ADDENDUM #1

Bldg. "D" Rmodeling, Bldg. "E" Addtion
Main Campus
McHenry County College
8900 US HWY 14
Crystal Lake, IL 60012

McHenry County College – Building D Remodel, Building E Addition
Pre-Bid Meeting Minutes
July 31, 2013

TYP. MOMENT CONN. DETAIL AT FLOOR 1

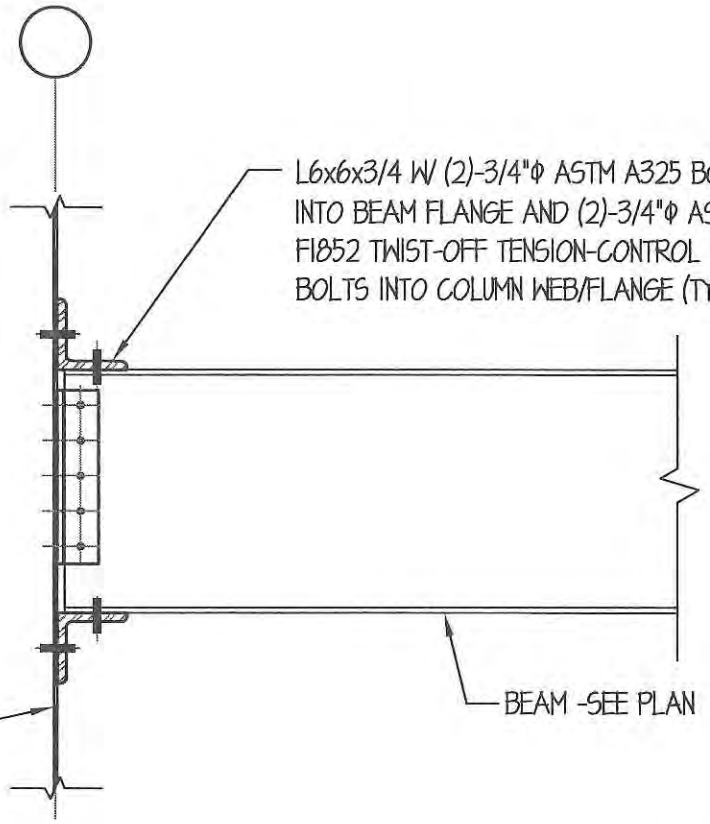
DETAIL APPLIES AT BEAM CONNECTIONS TO COLUMNS LOCATED AT 3/G.1, 4/G.1, 5/G.1, 3/D.1 & 5/D.1

10/S103 **TYP. MOMENT CONN. DETAIL AT ROOF** 1

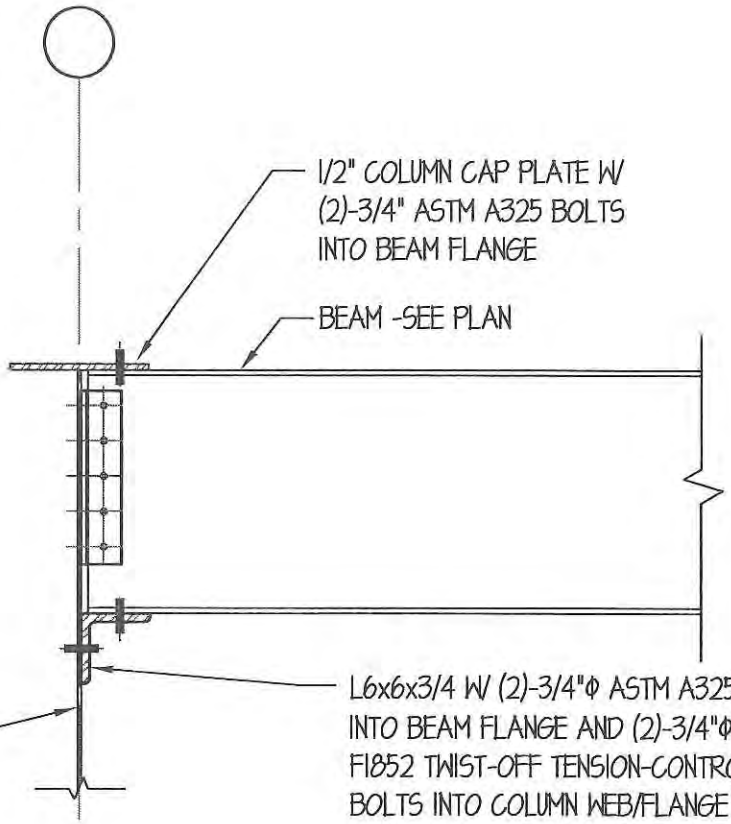
DETAIL APPLIES AT BEAM CONNECTIONS TO COLUMNS LOCATED AT 3/G.1, 4/G.1, 5/G.1, 3/D.1 & 5/D.1

PARTIAL FIRST FLOOR POWER PLAN

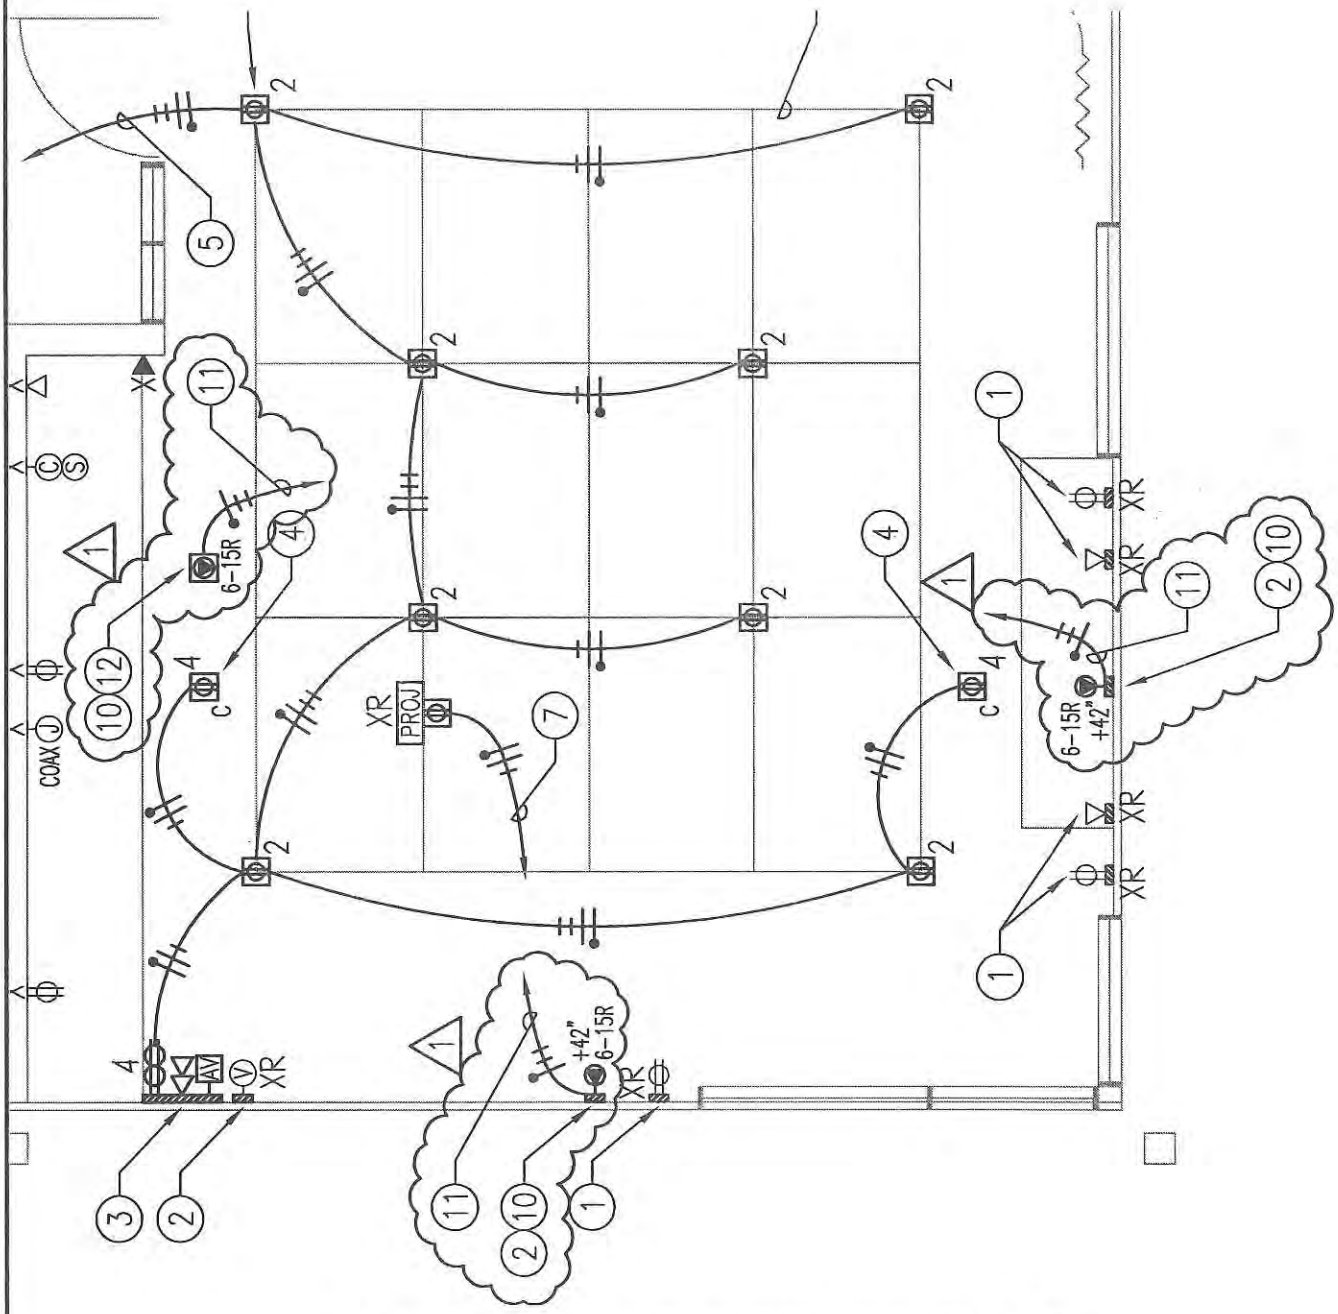
(10) VERIFY FINAL LOCATION AND EXACT ELECTRICAL REQUIREMENTS WITH OWNER FURNISHED EQUIPMENT PRIOR TO INSTALLATION. RECEPTACLE SHALL BE OF VOLTAGE RATING AND AMPACITY TO MATCH MANUFACTURER'S RECOMMENDATIONS. REVISE NEMA CONFIGURATION AS REQUIRED FOR PROPER EQUIPMENT OPERATION.

(11) WIRE ALL NEMA 6-15 RECEPTACLES TO (1) NEW 15A-2P CIRCUIT BREAKER OF TYPE TO MATCH EXISTING 208/120V PANEL WITH SPARE CAPACITY AND AVAILABLE SPACE. FIELD VERIFY EXACT REQUIREMENTS.

(12) CEILING MOUNTED RECEPTACLE FOR CORD REEL DEVICE. 600V CORD REEL WITH 50 FEET CORD LENGTH SHALL BE MANUFACTURED BY REELCRAFT #L-5550-124-X, FLYING LEAD REEL WITH CORD. PROVIDE WITH UL LISTED NEMA 6-15 PLUG FOR CONNECTION TO CEILING RECEPTACLE AND UL LISTED NEMA 6-15 RECEPTACLE AT THE OTHER END FOR CONNECTION TO OWNER FURNISHED EQUIPMENT. FIELD ASSEMBLE AND TERMINATE PLUG/RECEPTACLE TO FLEXIBLE CORDS. INSTALL PER MANUFACTURER'S INSTRUCTIONS.

FIRST FLOOR
FIRE PROTECTION DEMOLITION PLAN

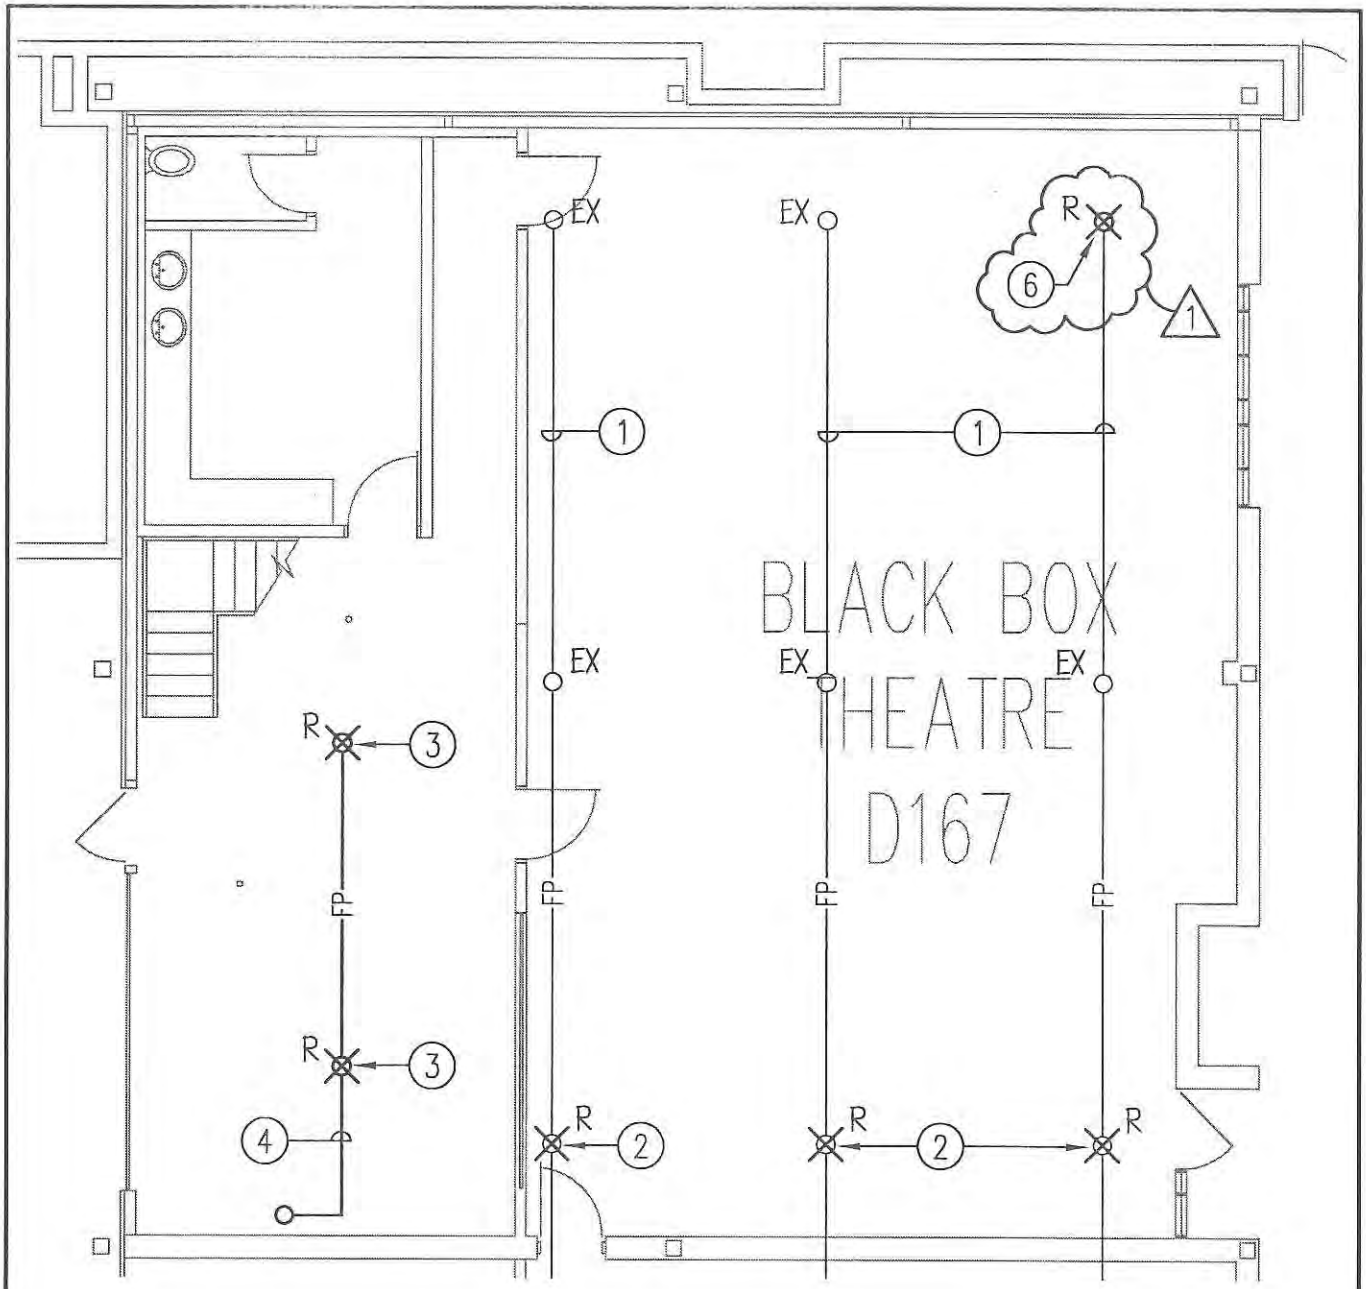
(6) REMOVE EXISTING SPRINKLER HEAD, EXTEND PIPING AS SHOWN.

(7) PROVIDE NEW SPRINKLER HEAD, TYPE AS SHOWN. EXTEND EXISTING PIPING TO NEW LOCATION.

FP3 FIRST FLOOR FIRE PROTECTION PLAN

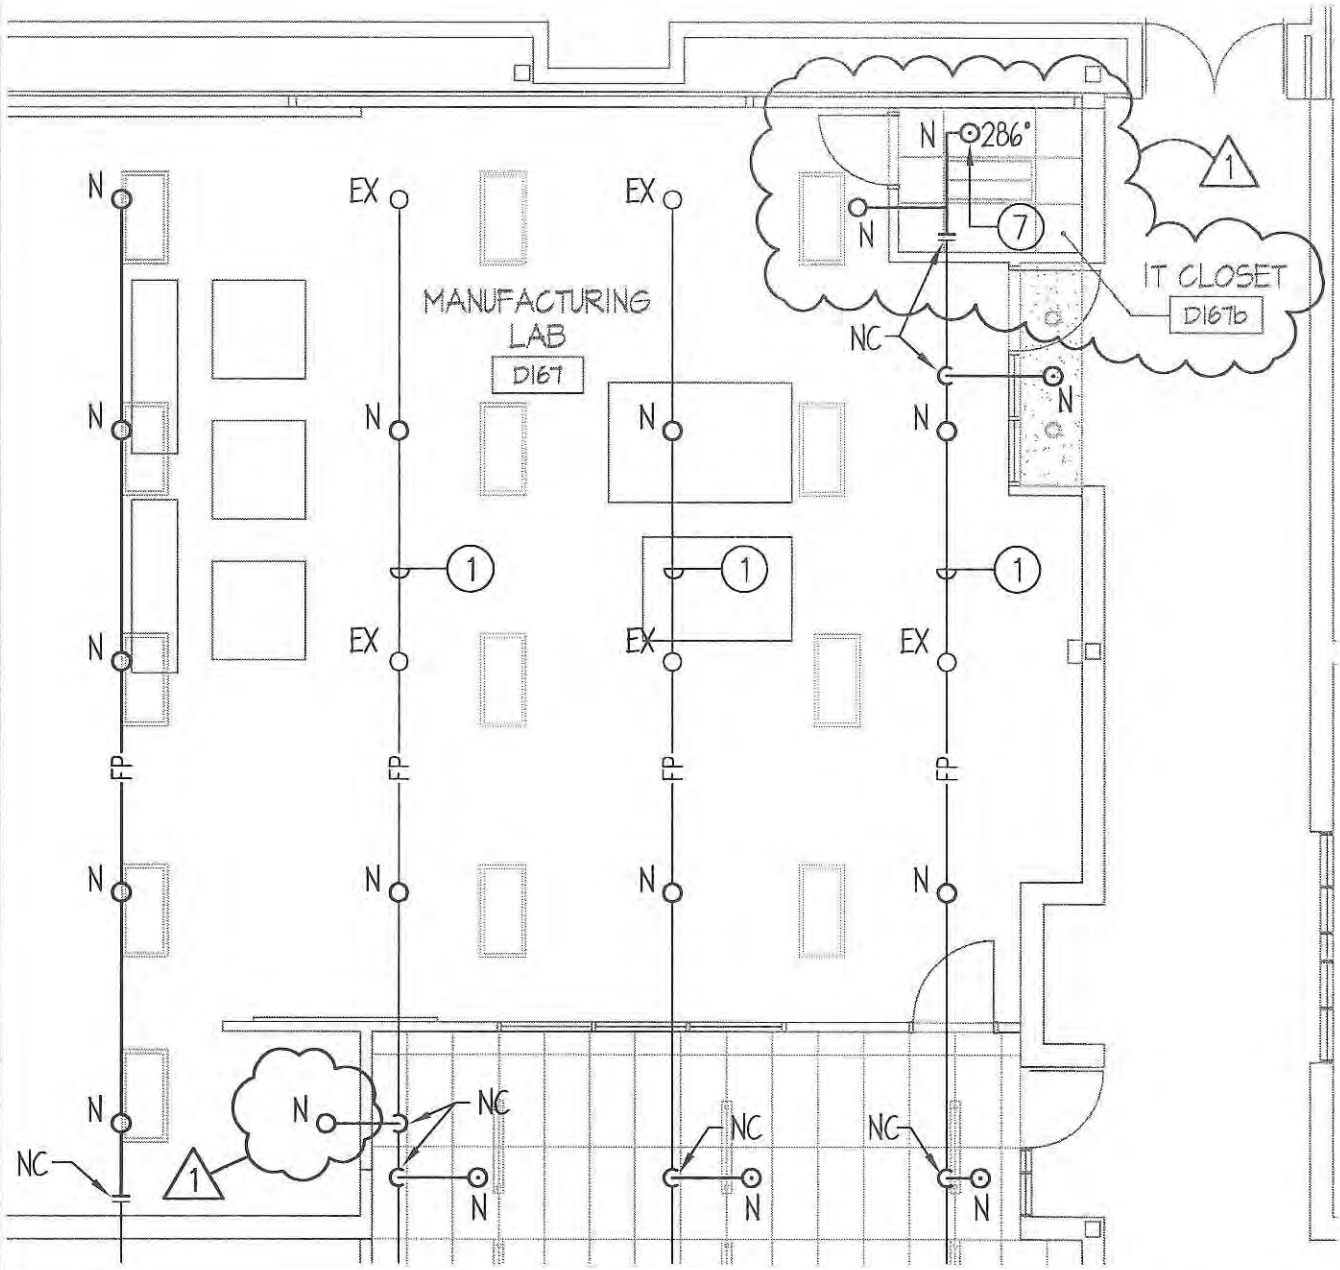
(6) REMOVE EXISTING SPRINKLER HEAD, EXTEND PIPING AS SHOWN.

(7) PROVIDE NEW SPRINKLER HEAD, TYPE AS SHOWN. EXTEND EXISTING PIPING TO NEW LOCATION.

E1 PARTIAL FIRST FLOOR POWER PLAN

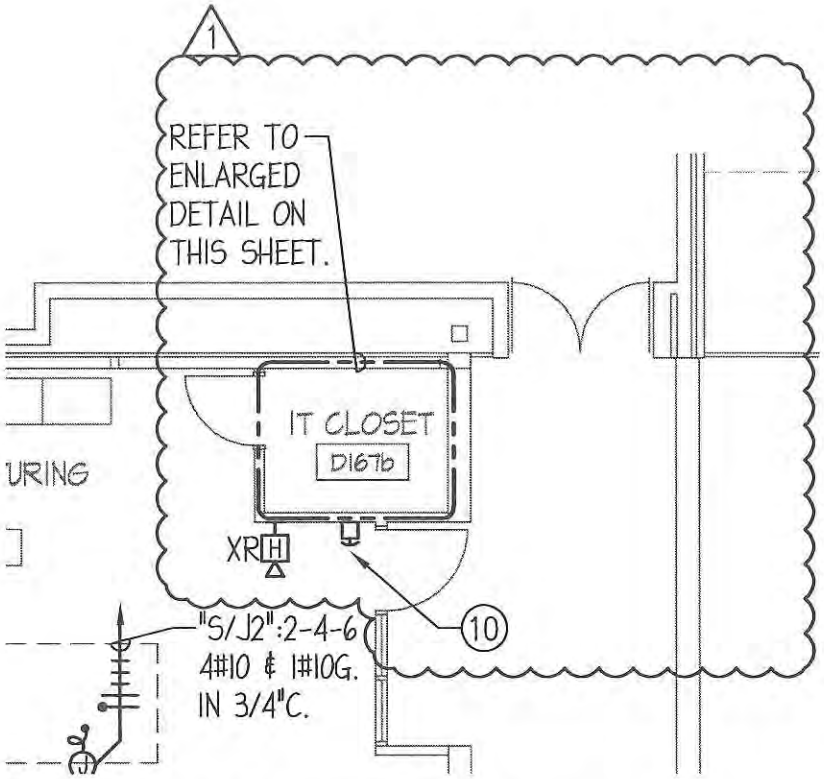
(3) PROVIDE TWO-COMPARTMENT STEEL POLE AS MANUFACTURED BY WIREMOLD 30TP-4V SERIES. FIELD VERIFY EXACT POLE LENGTH REQUIRED. PROVIDE WITH ADDITIONAL RECEPTACLE AND A/V OPENINGS (1) TO SERVE QUANTITY OF DEVICES SHOWN. SECURE POLE TO FLOOR & STRUCTURAL MEMBERS ABOVE. INSTALL PER MANUFACTURER'S INSTRUCTIONS.

(13) NOT USED. (1)

E2 ENLARGED IT CLOSET D167b

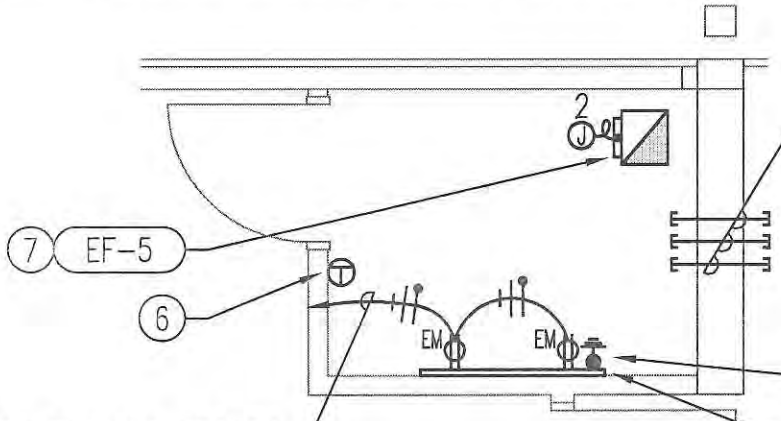
(3) 4" SLEEVES STUBBED INTO CORRIDOR CEILING SPACE FOR LOW VOLTAGE CABLE.

48" X 96" X 3/4" PLYWOOD TREATED WITH (2) COATS OF FIRE RESISTANT PAINT FOR GROUND BAR AND MISCELLANEOUS LOW VOLTAGE TERMINATIONS.

WIRE TO EXISTING BRANCH CIRCUIT IN PANEL "S/E" SERVING IDF CABINET AT FORMER LOCATION. FIELD VERIFY EXACT REQUIREMENTS.

E1 PARTIAL FIRST FLOOR LIGHTING PLAN

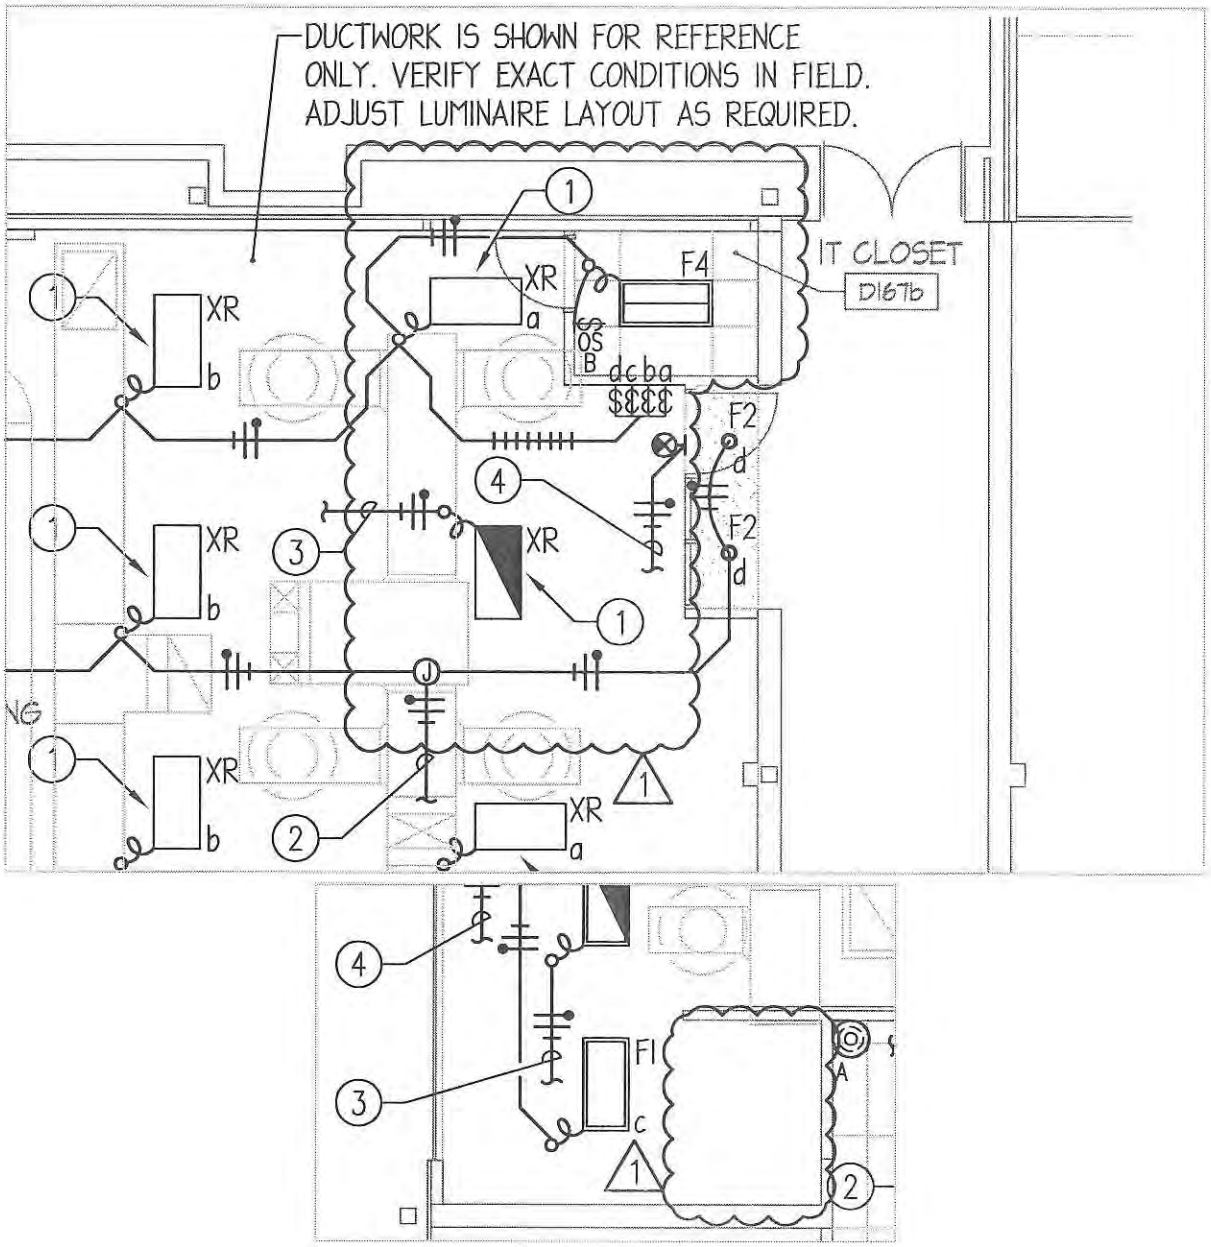
3. RECONNECT TO EXISTING BRANCH CIRCUIT SERVING EXTERIOR LIGHTING. MAINTAIN EXISTING EXTERIOR LIGHTING CONTROL AS REQUIRED. FIELD VERIFY EXACT REQUIREMENTS.
